Brookhaven National Laboratory
Plant Engineering - E&CS Division
Engineering Change Notice Form

PROJECT: CCWF II

ECN Title: Temporary Enclosure over Cooling Tower Basin

ECN No. 43

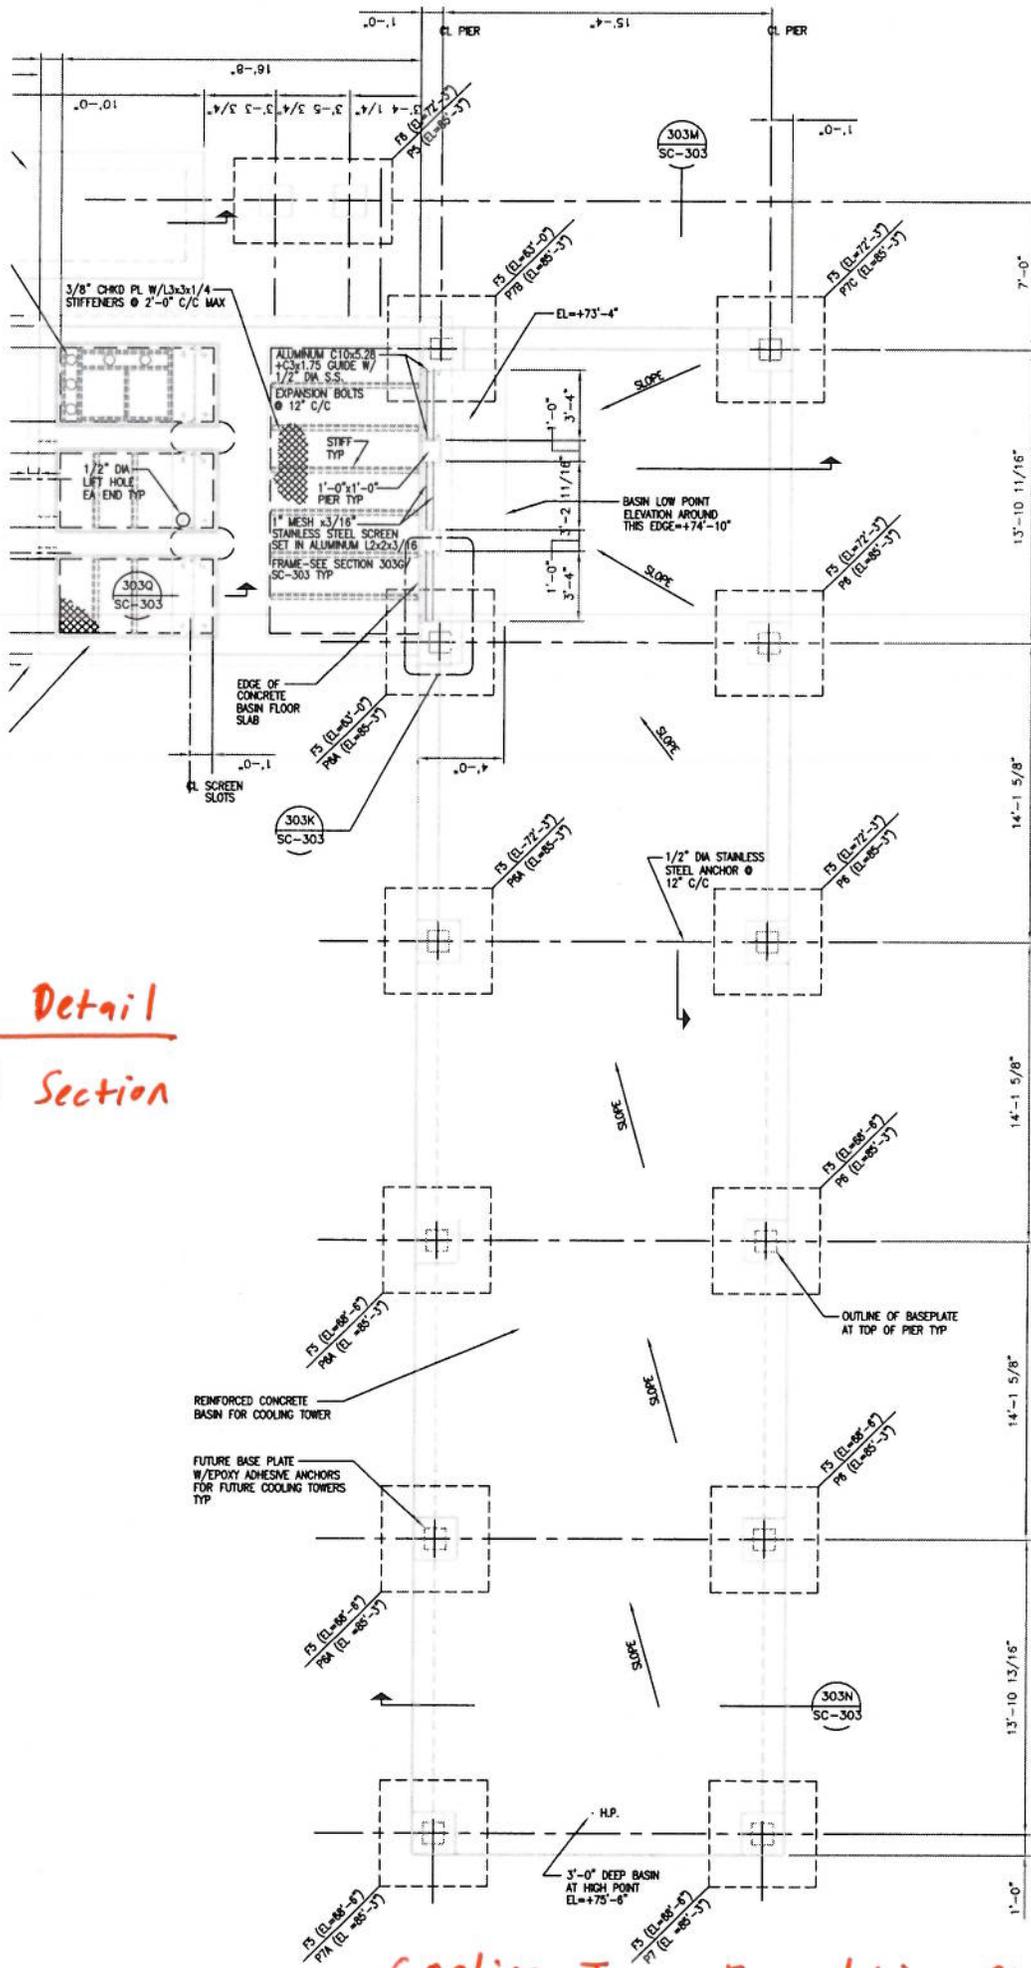
Delete Detail
 120A Section

Cooling Tower Foundation Plan

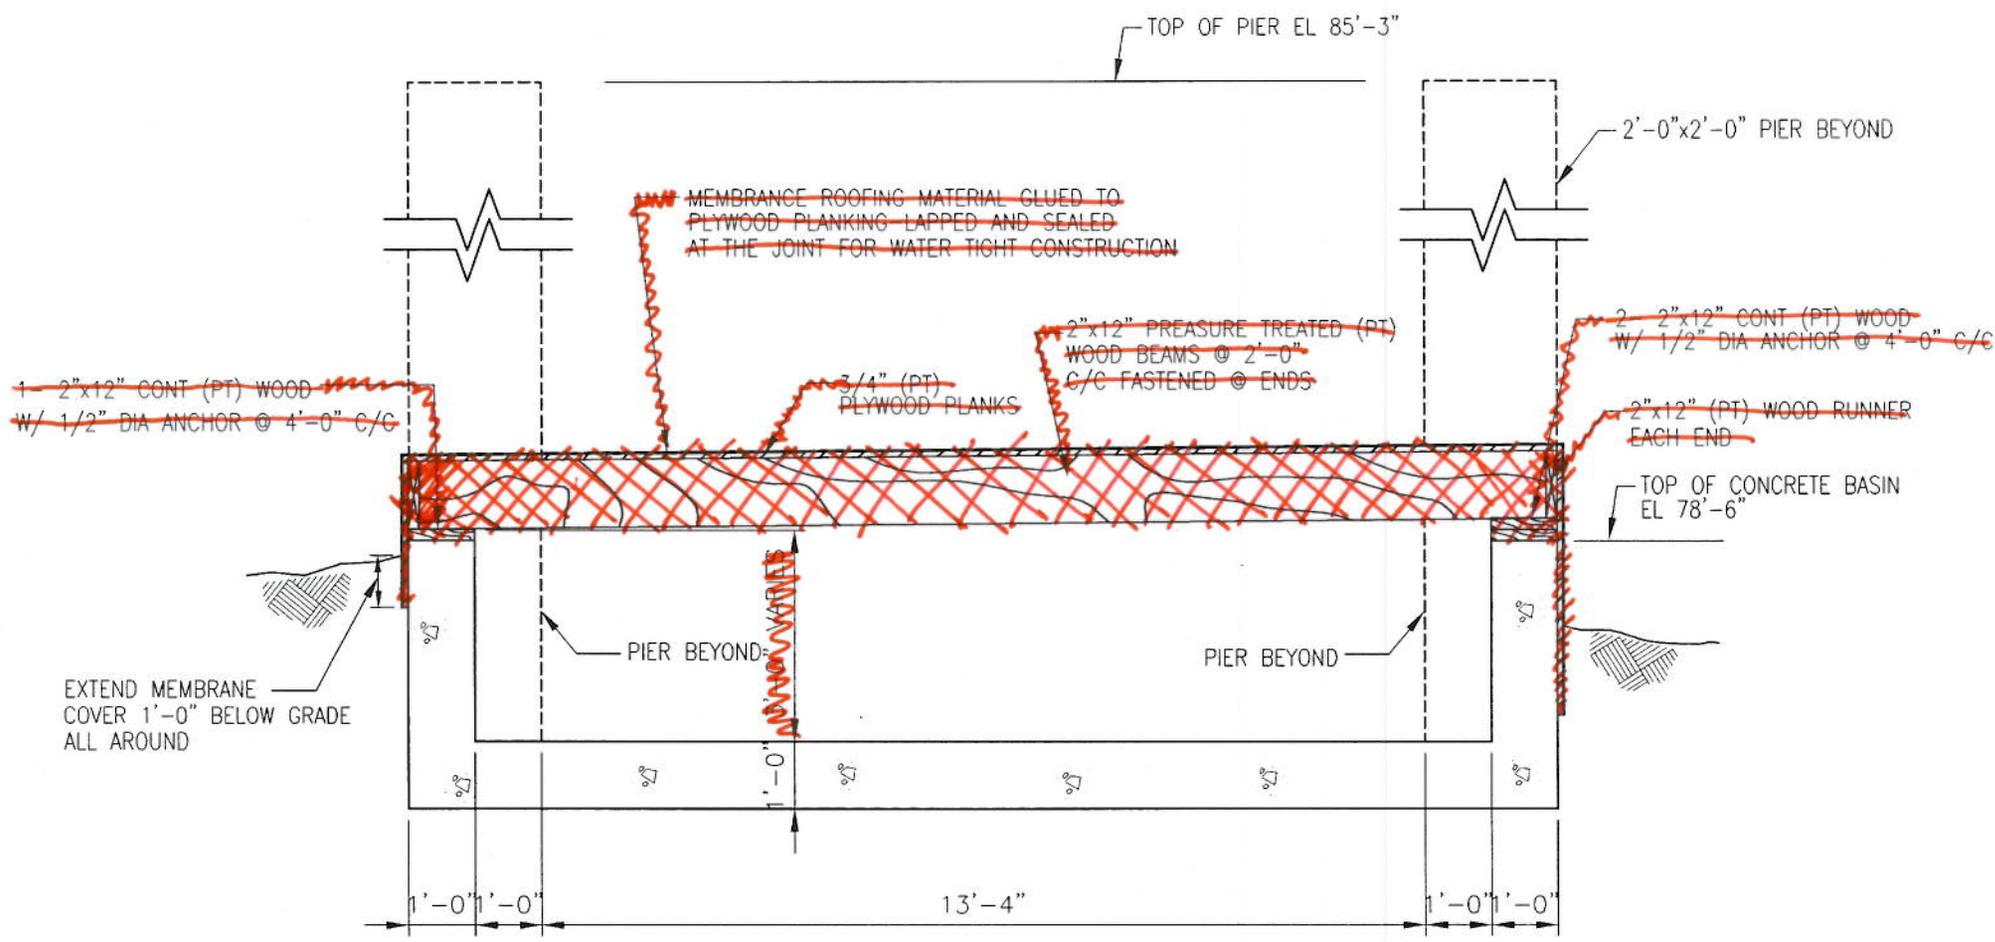
Requested Change (Attach sketch if applicable): Temporary Enclosure Assembly over the South end of the Cooling Tower Basin is not being installed due to Future Cooling Tower cells being installed.

Resolution: See the attached sketch.
